Applicant: Boardman et al.	:
	:
Serial No.: 10/661,847	:
	:
Filed: September 12, 2003	:
	:
For: MODULAR REACTOR	:
CONTAINMENT SYSTEM	:

PETITION FOR WITHDRAWAL OF HOLDING OF ABANDONMENT

AMENDMENT AFTER FINAL OFFICE ACTION

FIG. 4

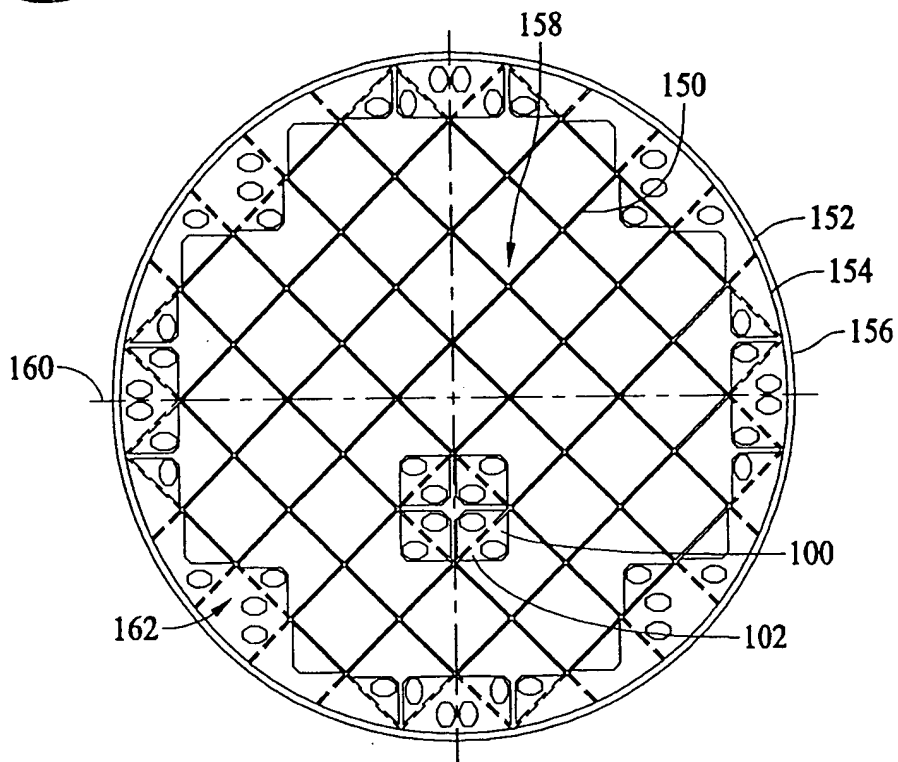
The objection to the drawings under 37 CFR 1.48(p)(4) is respectfully traversed.

An amended Figure 4 deleting reference number 164 is submitted herewith for approval. Applicants submit that the drawings meet the requirements of 37 CFR 1.48(p)(4). Accordingly, Applicants respectfully request that the objection to the drawings under 37 CFR .48(p)(4) be withdrawn.

Applicants have amended paragraph [0026] and Figure 4 to delete reference number 164. Also, Figure 8 has been amended to remove the protrusion from the beam and reference number 164. Applicants submit that Figure 8 is a sectional view of originally filed Figure 4 that illustrates support beam 150 received in groove 122 of support plate 100. Support for this Figure is found in originally filed paragraph [0026] and originally filed Claim 1. No new matter has been added. Further, Applicants submit that Figure 8 is a schematic illustration that shows the relationship of the elements of the core support apparatus. Figure 8 is not a construction drawing meant to show exact sizes of the beam, the support plate, and the groove.

FIG. 8

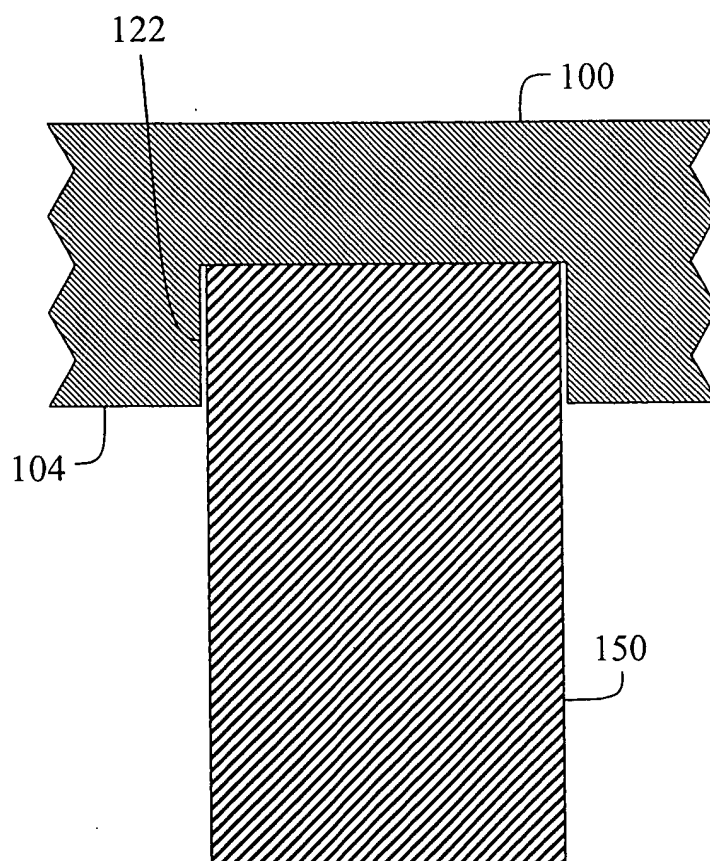
The objection to the drawings under 37 CFR 1.83(a) is respectfully traversed.

Applicants submit herewith an amended Figure 8, for approval. Figure 8 is a sectional view of originally filed Figure 4 that illustrates support beam 150 received in groove 122 of support plate 100. Support for this amendment is found in paragraph [0026] and originally filed Claim 1. No new matter has been added.

beam is positioned in said groove, said removable support plate in direct contact with said beam". Amended Figure 8 clearly illustrates the support beam 150 positioned in the groove 122 and that the support beam 150 and the support plate 100 are in direct contact.
